Ridgway Town Council
Special Meeting Agenda
Wednesday, August 3, 2022

1. **Application:** Preliminary Plat for Subdivision and Planned Unit Development; **Location:** Town of Ridgway, Block 30, Lots 1-12; **Zone:** Historic Residential (HR); **Applicant:** David Bruce; **Owner:** Ridgway Homes, LLC

To: Town of Ridgway Planning Commission
Cc: Preston Neill, Ridgway Town Manager
From: TJ Dlubac, CPS, Contracted Town Planner
Date: July 29, 2022
Subject: Yellow Brick Lane Sketch Plan and Preliminary Plat for Subdivision and PUD Staff Report for August 3rd Special Town Council Meeting

Sheet
RD0.00

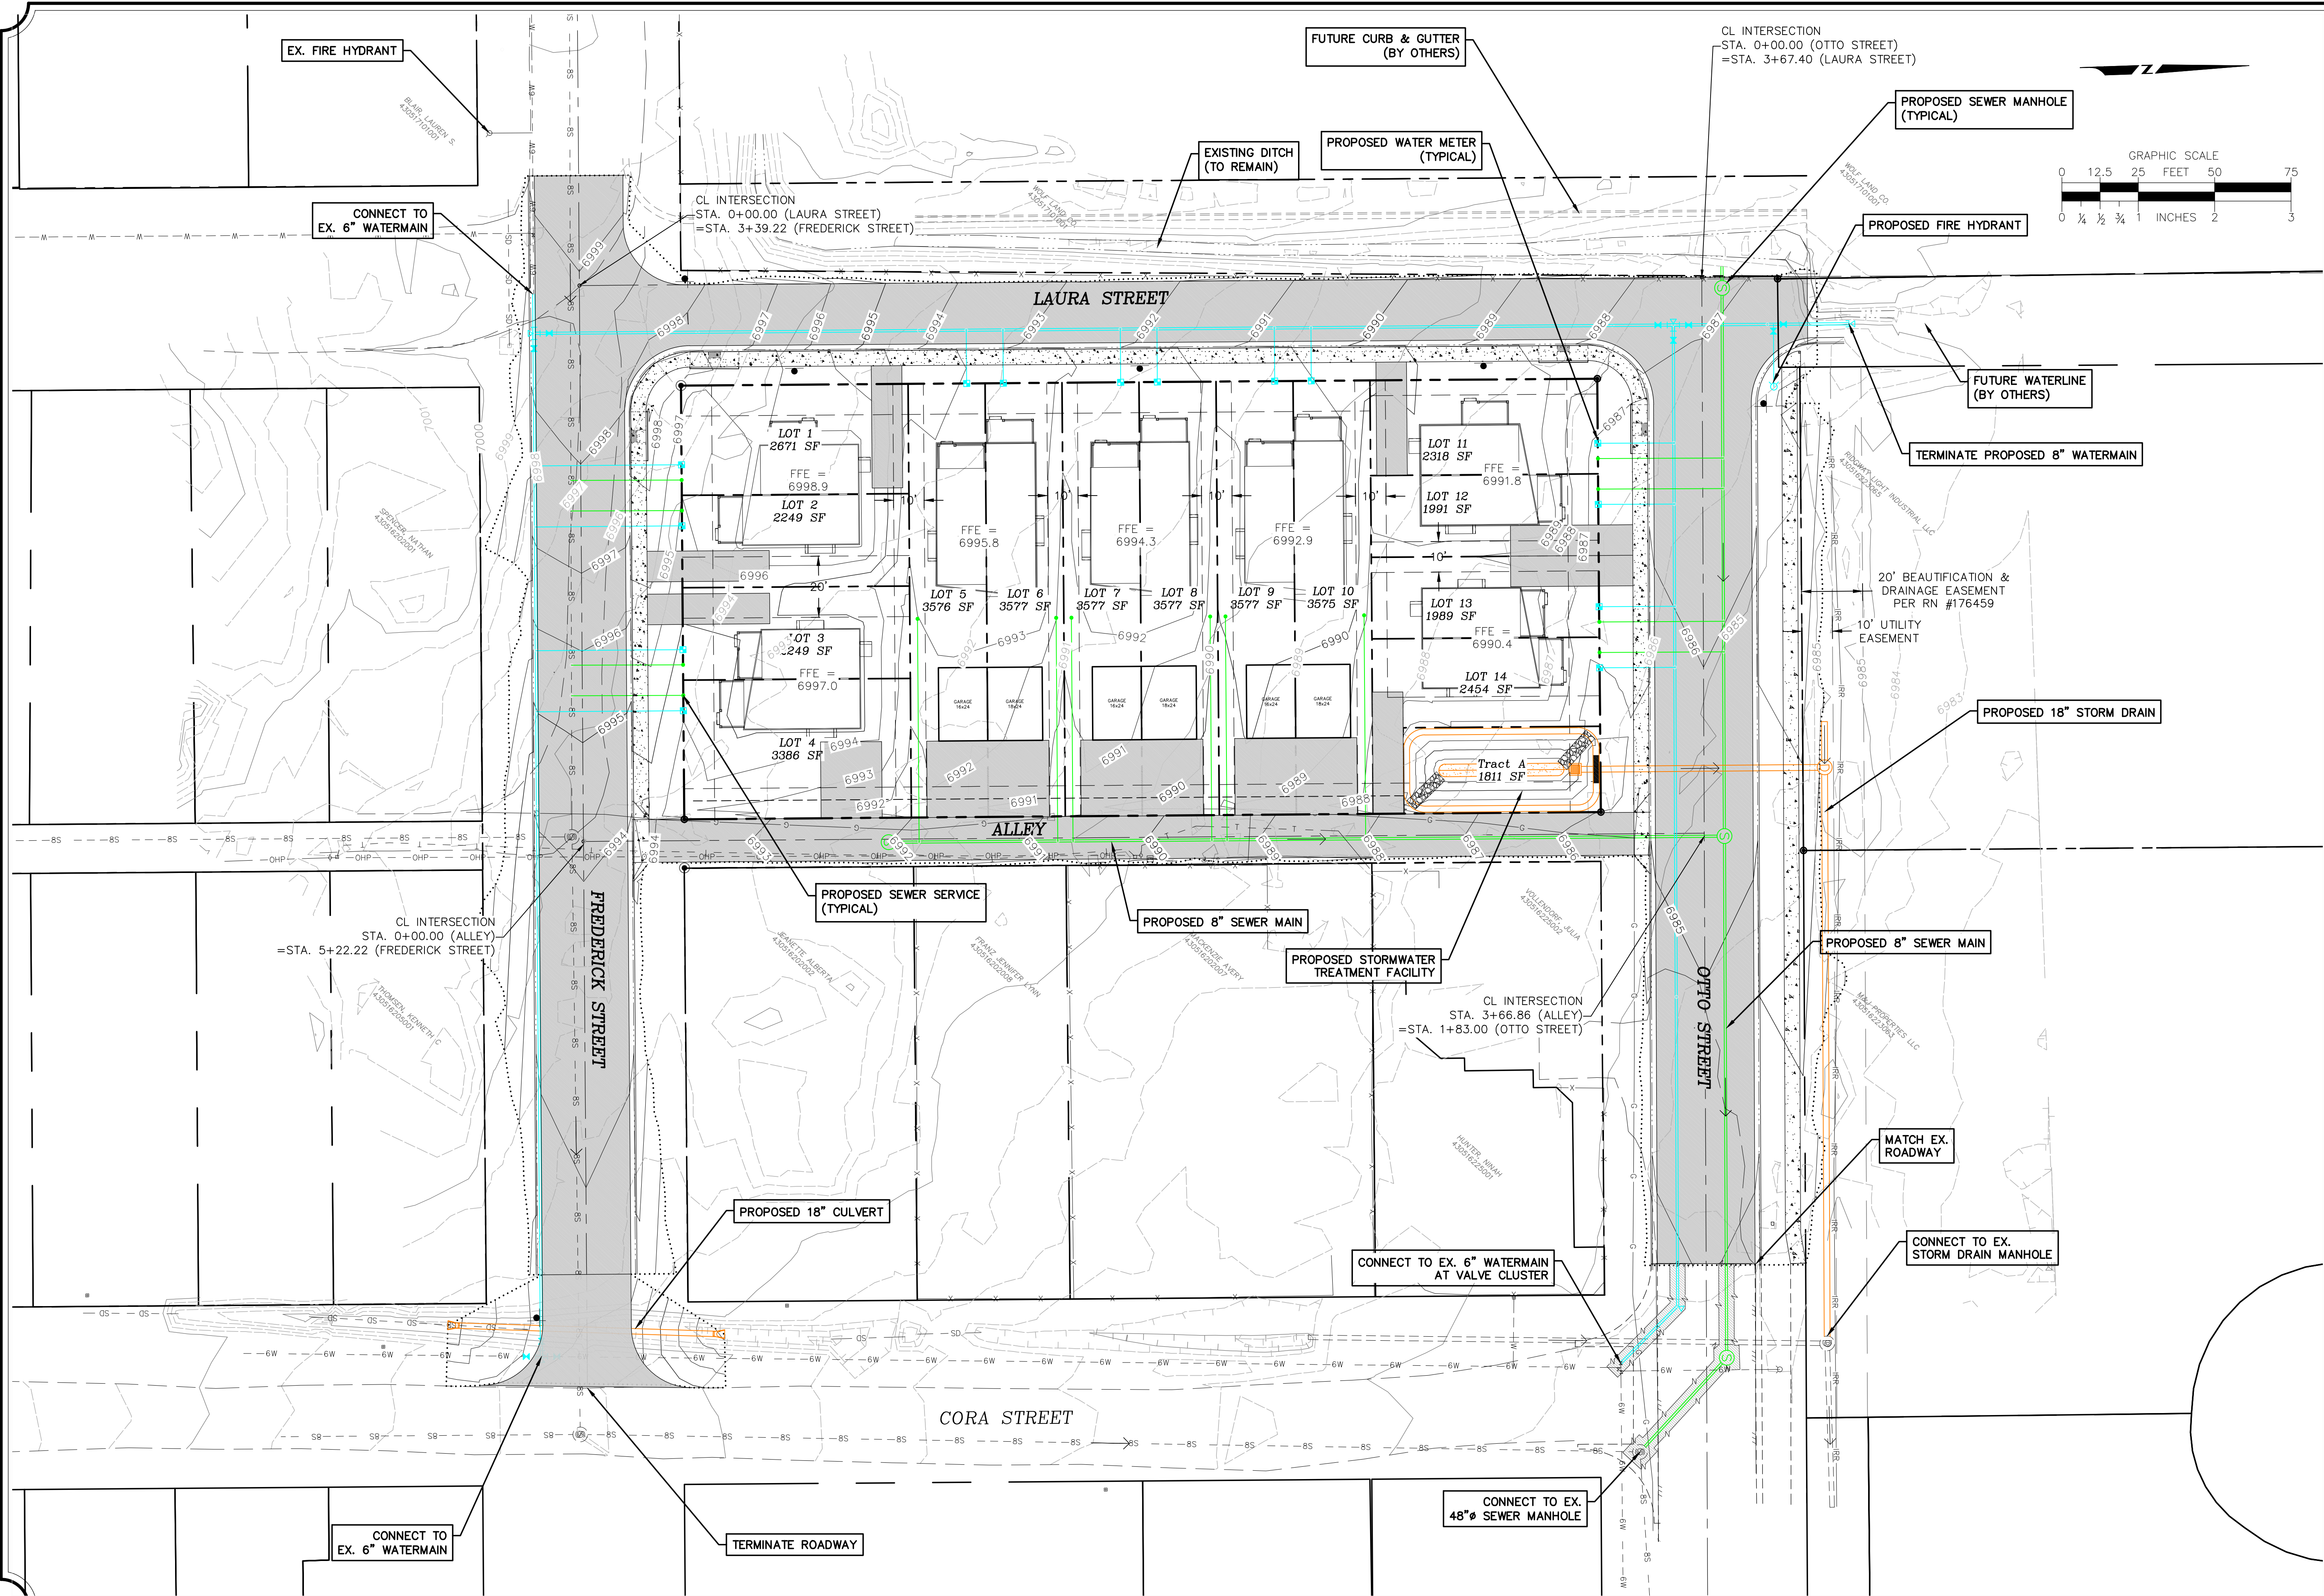
Civil Plans	9	RD0.01	Storm					Driveways for lots 2 and 3 are in runoff flow paths. Anything to insure they don't obstruct the flow? Is water going N or E	Refer to Overlot grading plan sheet RD0.01 which conveys storm water across gravel driveway. The CCR's for the subdivision specify that drainage conveyances must be maintained.
Civil Plans	26	SW1.01	Storm					There is no forebay for the basin. Required by standards because it eases maintenance and without it the effectiveness and infiltration rate of the filter media will decrease rapidly	Forebay will be incorporated into pond facility. Revised drainage report forthcoming July 22nd.
Civil Plans	26	SW1.01	Storm					What's the maintenance plan for the basin?	Tract A will be owned and maintained by Ridgway Homes LLC and its dedication has been amended on the Plat.

RD0.01			Interior drainage swales are proposed to serve this function, and have been colored "blue" to provide clarity.	The swale between lots 12 and 13 does not appear to go the treatment facility. At the south end of the swale between 12 and 13, it looks like the water from the west has a choice to go N or E. It should be forced to the east to the treatment facility.	developed flow patterns have been revised for clarity.	Clarified that the n/s ditch does not extend to e/w ditch.

Sheet
SD1.01

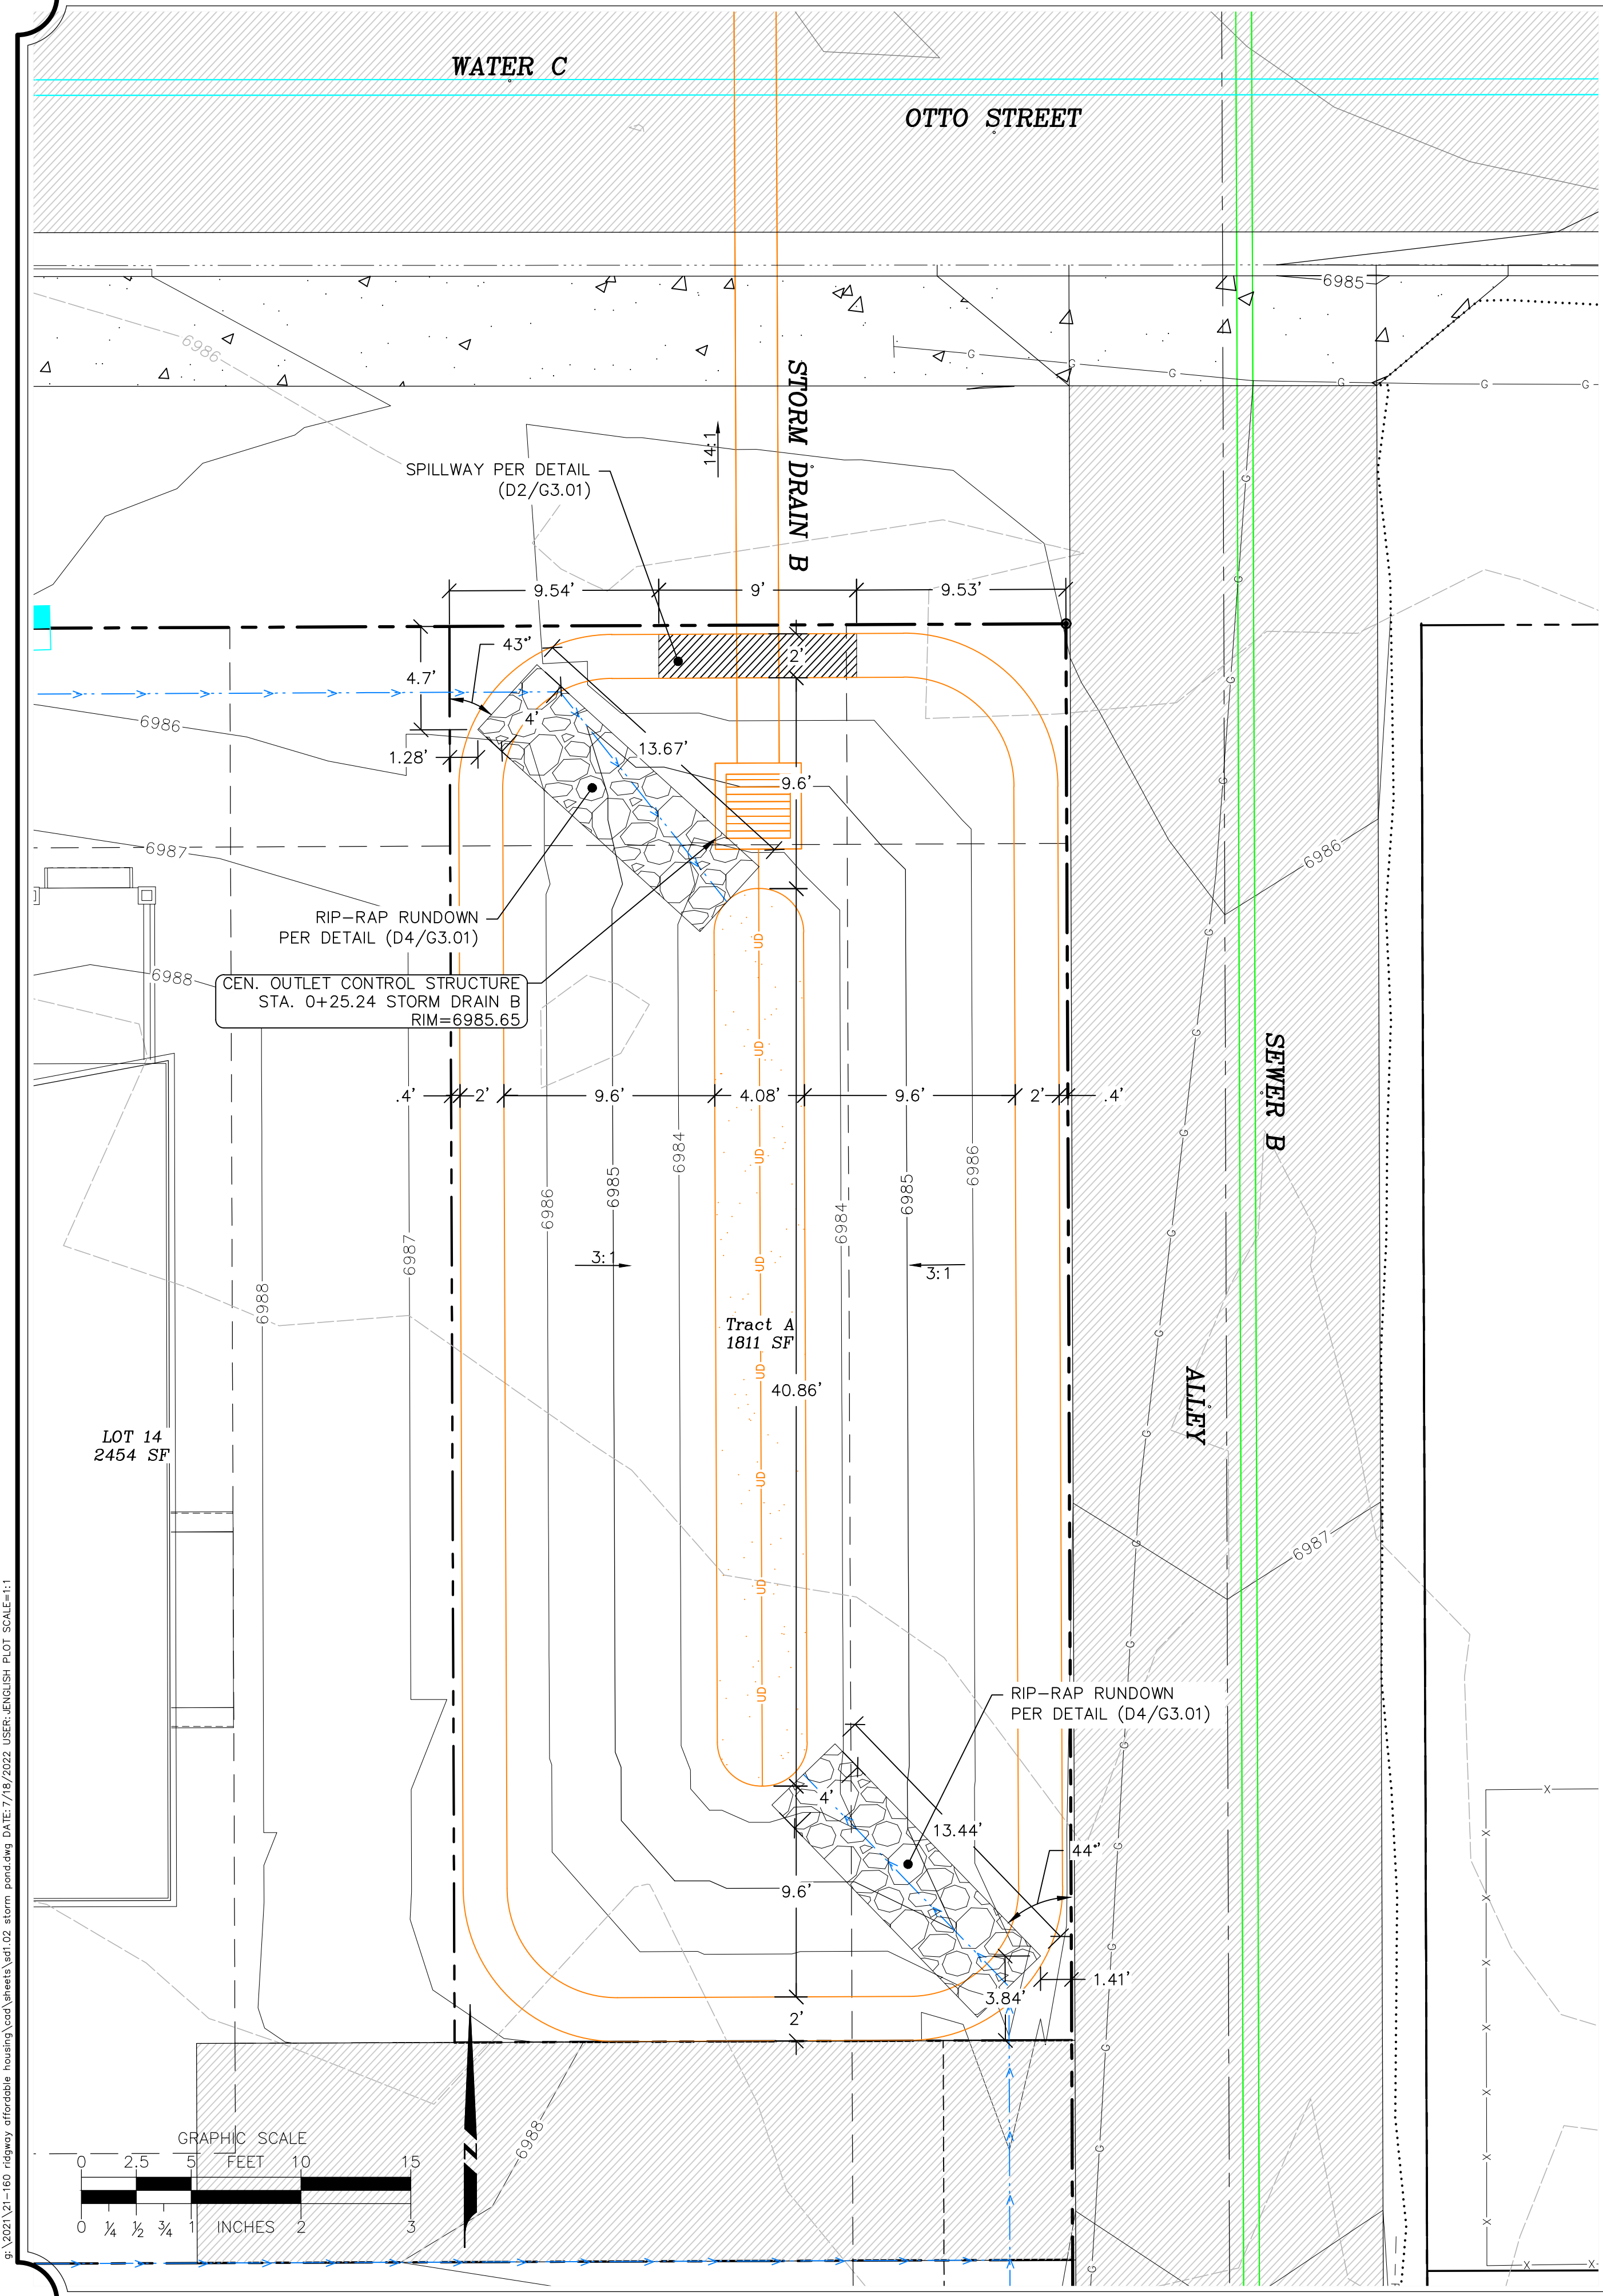
Storm						Spillway is in the ROW	Spill way has been terminated at ROW.	Sheet SD1.01 shows riprap in the ROW.	Rundown and spill way are contained entirely within YBR property. Spill way has been revised to specify concrete pavement
						Where are the dimensions for the pond. Topo in the pond shows square corners. How will those be constructed?	Pond geometry has been revised and annotated on plan sheet SD1.01	Ok, still show rundown encroaching into the alley. The rundown is shown 11.5 long, but there is no dimension to tie it to either property line. Similarly the riprap on the outfall is shown extending into ROW and lacks adequate dimensions. Also not seeing the overall length on the pond. Should TC allow the use of the alley for development storm water transport, we will have to discuss that.	Rundown and spill way are contained entirely within YBR property. Spill way has been revised to specify concrete pavement. Sheet SD1.02 has been added to show full extents of the pond with dimension ties to both riprap spillway and outfall.

Storm				Spill way has been terminated at ROW.	Sheet SD1.01 shows riprap in the ROW.	Rundown and spill way are contained entirely within YBR property. Spill way has been revised to specify concrete pavement	Ok
				Pond geometry has been revised and annotated on plan sheet SD1.01	Ok, still show rundown encroaching into the alley. The rundown is shown 11.5 long, but there is no dimension to tie it to either property line. Similarly the riprap on the outfall is shown extending into ROW and lacks adequate dimensions. Also not seeing the overall length on the pond. Should TC allow the use of the alley for development storm water transport, we will have	Rundown and spill way are contained entirely within YBR property. Spill way has been revised to specify concrete pavement. Sheet SD1.02 has been added to show full extents of the pond with dimension ties to both riprap spillway and outfall.	Ok
